Final Environmental Impact Report

San Bernardino County Overnight Solar Project

SCH No. 2024010434

2.0 COMMENT LETTERS AND RESPONSES TO COMMENTS

**Figure 3.3-5. Burrowing Owl Survey Results**

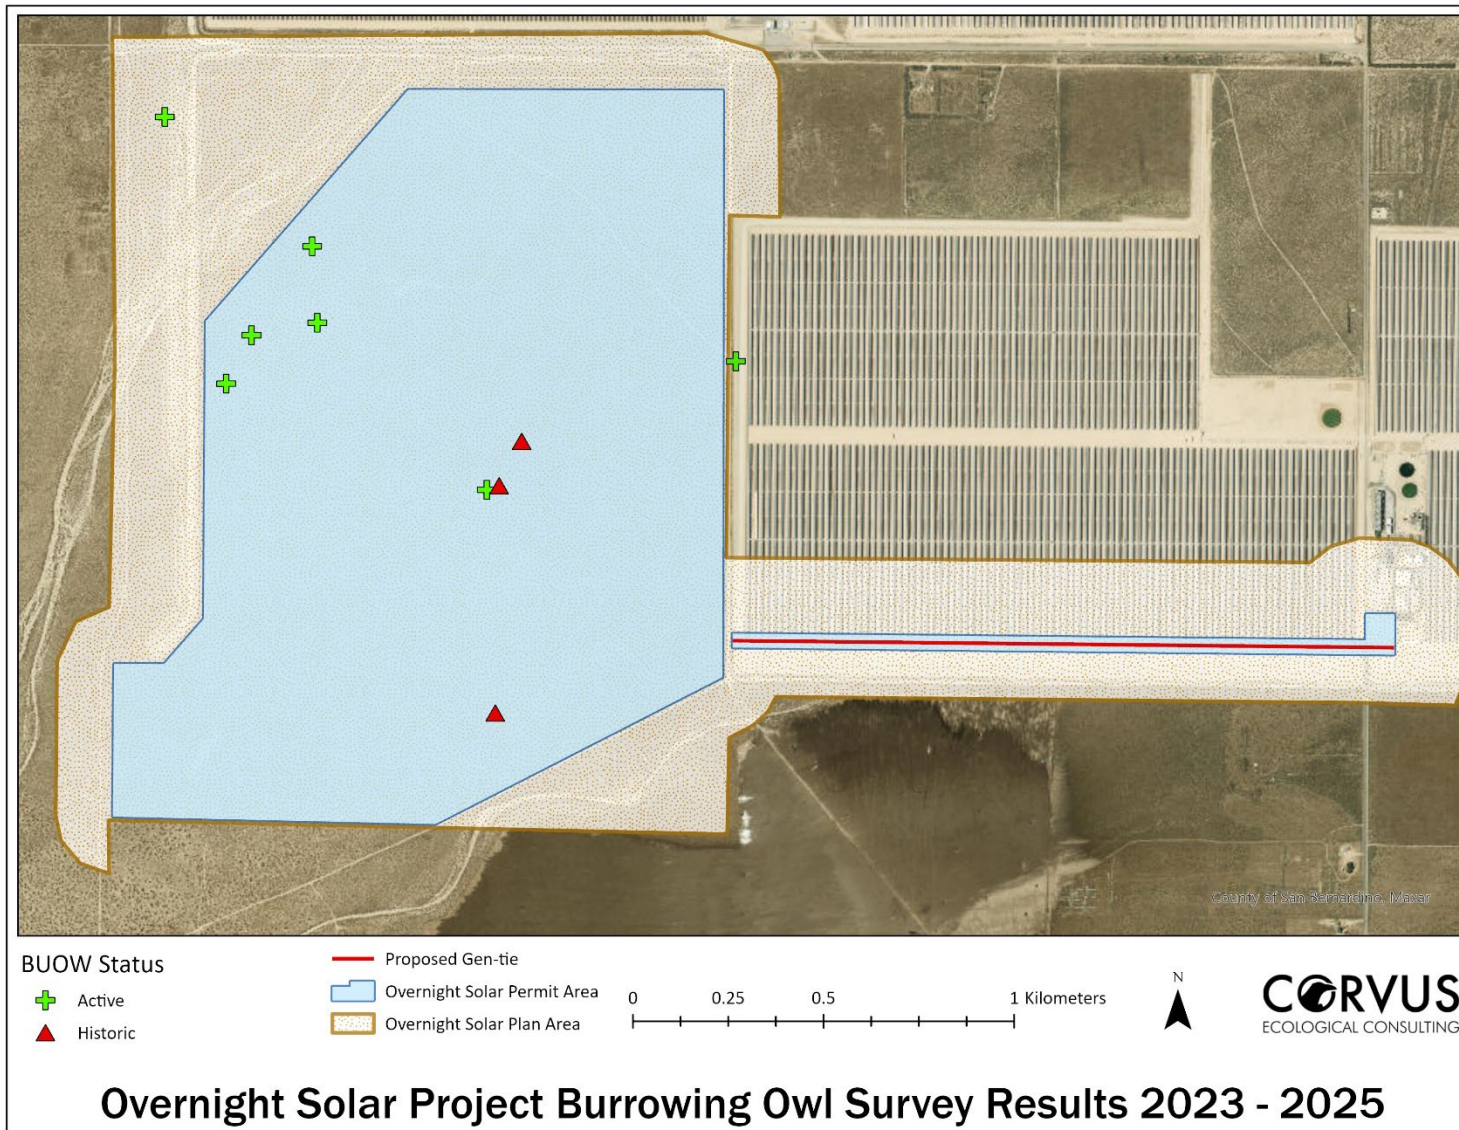
Initial burrowing owl surveys were conducted during peak breeding season in 2023 (April 15 to July 15), with two biologists walking 10-meter belt transects across the original survey area. Biologists examined natural and artificial substrates for occupation by western burrowing owl, and recorded signevidence of use (i.e., feathers, pellets, burrows, whitewash, egg fragments, live animals/breeding pairs, and live birds). Biologists marked all occupied and suitable burrowing owl burrows during this effort. During May 2023, ~~and April 2024, and March 2025,~~ all suitable western burrowing owl burrows were revisited in an effort to determine occupancy and site use. Additional western burrowing owl focused surveys were performed in May, June, and July 2024, within the current project site and a 150-meter buffer. The proposed gen-tie corridor was surveyed for burrowing owl on March 26, 2025. Signs of burrowing owl use were considered “historic” if detected within 2023 or 2024 and “active” if detected within 2025. No live Three historic signs and five active signs of burrowing owls use were have been observed within the current project footprint, one active sign of burrowing owl use has been observed northwest of the project footprint, and one active sign of burrowing owl use has been observed within the Mojave Solar Facility (Figure 3.3-5); however, evidence of their presence was recorded in the form of active soil burrows, scat, and pellets (Figure 3.3-3). The occupied burrowing owl burrow within the 150-meter buffer of the current project footprint within the existing Mojave Solar Facility, was detected more than 875 meters from the proposed project gen-tie located in the facility (Figure 3.3-5). However, no signs of burrowing owl use were observed along the proposed gen-tie corridor within Mojave Solar Facility during the 2025 surveys. For these reasons, western burrowing owl is ~~assumed-determined~~ to be present within and around the project footprintsite.
